Index 102-600

General Information for Traffic Control Through Work Zones

These changes for FY 2023-24 include consolidation of Material/APL requirements into Specification 990. The Index was reorganized to streamline where information was found (e.g., sign notes and information was moved to be on the same sheet as work zone signs). Updated 'lane widths' requirements to add direction to get concurrence from the Engineer on which lane will be the designated 12' and added 12' minimum lane width for single-lane ramps. Added new requirement to reestablish existing posted speed by adding a posted speed limit sign for locations where an existing sign isn't present within "X" distance from the last work zone sign or channelizing device. Added auxiliary lane (turn-lane) closure detail to clarify the layout previously noted on Index 102-615, Sheet 2 & 3. Added a basic survey work zone sign layout detail.

===== SPEED REDUCTION SIGNING =====

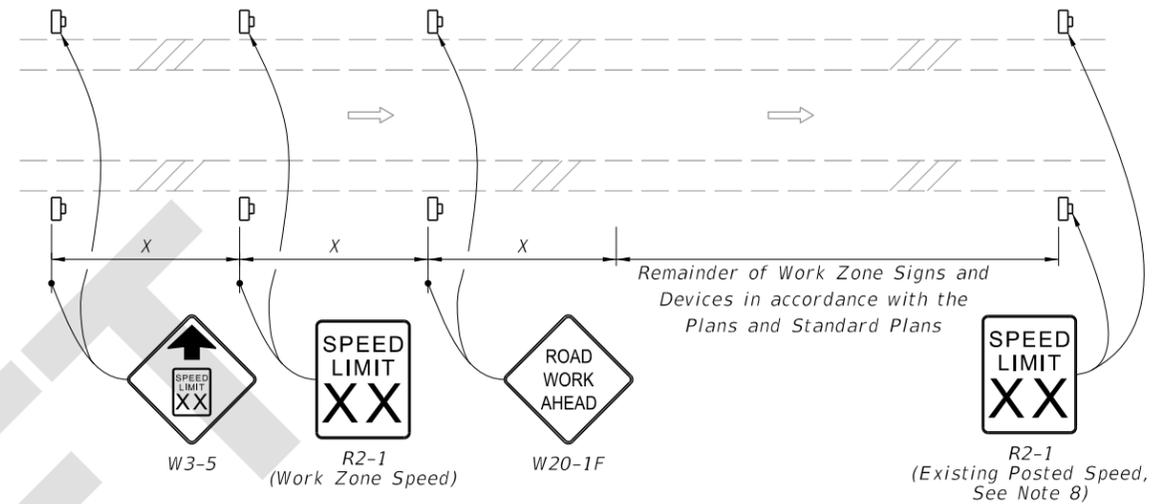
COMMENT: Note 8 on Sheet 3 of 10, is that in the current index? This note is a problem from a liability standpoint as we need to clearly delineate where the work zone ends. We need to modify to eliminate the option of not putting an “End Work Zone” sign.

RESPONSE: The current criteria and standards require reduced work zone speeds to be confined to the proximity of the work activity necessitating the reduction, and also requires that the existing posted speed must be restored as soon as the TTC/work operation meriting the reduction is completed. However, direction or details on exactly how to accomplish this was not previously included, which is why we added the note. The original comment that led us to add the “End Work Zone Speed Limit” sign (R2-12) as the standard (with a “Speed Limit” sign as an option) is shown below. It came from Michael Drew with the Preferred Materials (email attached). We originally had the “Speed Limit” sign as the standard but adjusted based on the comment. We can revert back if you would prefer.

CHANGE MADE TO INDEX: Reverted to original layout with the SPEED LIMIT sign as the standard to the Speed Reduction Signing Detail.
